Public Service Commission

February 8, 2010

The Reclamation Division has conducted a completeness review of the application for Revision No. 30 to Surface Coal Mining Permit No. BNCR-9702 for the Center Mine in accordance with NDAC 69-05.2-05-01(2). This revision proposes to add 676.48 acres to the permit extending the permit boundary further west in Sections 21, 29, and 32 and converts the permit document into an electronic format. The following items must be satisfactorily addressed before the Reclamation Division can deem the application complete. Please note that our rationale for many of the items is based on the requirement in NDAC 69.05.2-05-02(1) that information be presented clearly and concisely.

Figure 1:

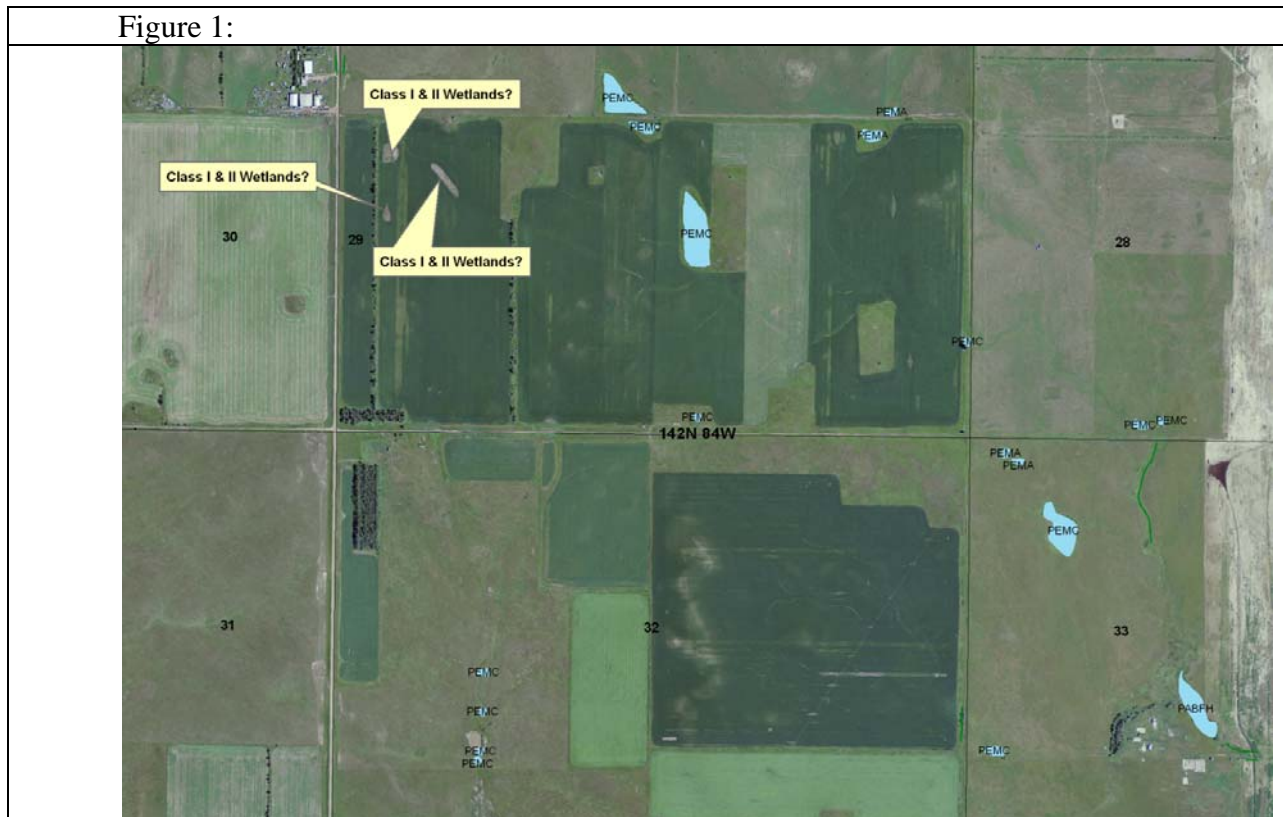
identification process as required by our guidelines. These additional NWI wetland features are delineated in Figure 1 below. (GAW)

35. The 2009, 2005 and 2003 NAIP aerial imagery shows what appears might be temporary wetlands in the cropland in the NW $\frac{1}{4}$ SW $\frac{1}{4}$ of Section 29. Please review and discuss as necessary to clarify. These features are identified in Figure 1 below. (GAW)
